Product / Process Change Notification (PCN)

PCN Number: PCN_WSEN-ISDS_20241022 Affected Series: WSEN-ISDS Affected Order Codes: 2536030320001, 25360303200011 PCN Date: 2024-07-22 (YYYY-MM-DD) Effective Date: 2024-10-22 (YYYY-MM-DD)	Change Category: ☐ Equipment/Location ☒ General Data ☐ Material ☐ Process ☐ Product Design ☐ Shipping/Packaging ☐ Supplier ☐ Software
Contact: Product Management Phone: +49 (0) 7942 - 945 5001 Fax: +49 (0) 7942 - 945 5179 E-Mail: pcn.eisos@we-online.com	Datasheet Change: ☒ Yes ☐ No Attachment: ☐ Yes ☒ No

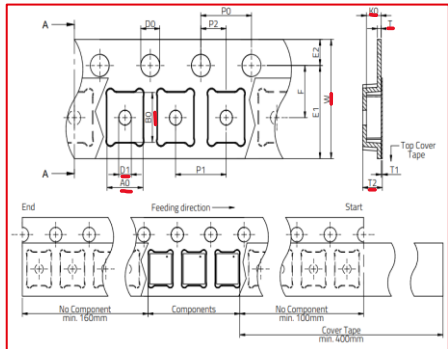
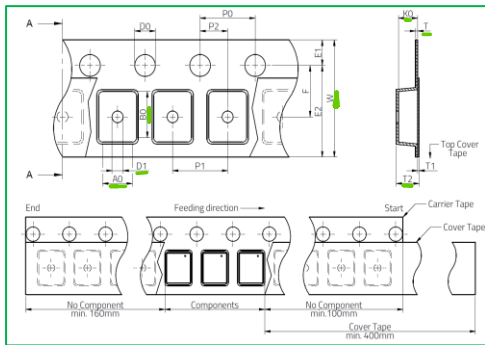
- Packaging drawing and specification of the tape (only applicable for 2536030320001) – The drawing of the tape and the dimensions are corrected.
- Figure showing the sensing axes of the sensor (applicable for 2536030320001, 25360303200011) – Figure is corrected.
- Packaging specification of the reel (only applicable for 25360303200011) – One of the reel dimensions is corrected.

Change 2 – Change in figure showing the sensing axes of the sensor: (2536030320001, 25360303200011)

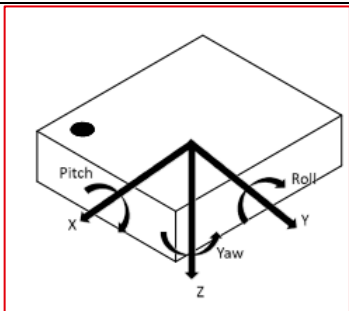
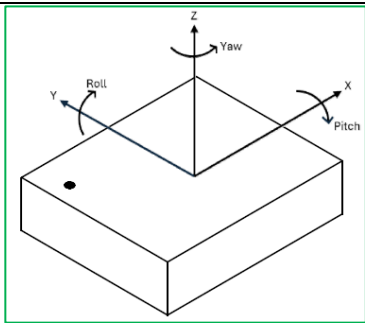
Before Change	After Change

Change 1 – Packaging drawing and specification change: (2536030320001)

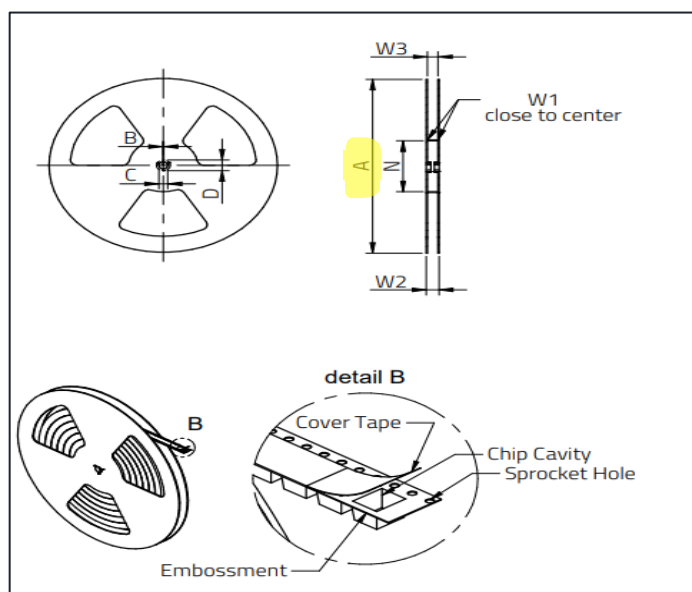
Before Change	After Change
Picture:		
A0	2.84 mm (Tolerance = typ.)	2.75 mm (Tolerance = +0.15)
B0	3.35 mm (Tolerance = typ.)	3.45 mm (Tolerance = +0.15)
W	8 mm (Tolerance = +0.3/-0.1)	8 mm (Tolerance = ±0.3)
T	0.30 mm (Tolerance = ref.)	0.25 mm (Tolerance = ±0.02)
T2	1.36 mm (Tolerance = typ.)	1.65 mm (Tolerance = typ.)
K0	1.16 mm (Tolerance = typ.)	1.30 mm (Tolerance = +0.1)
D1	0.30 mm (Tolerance = min.)	1.00 mm (Tolerance = +0.2)
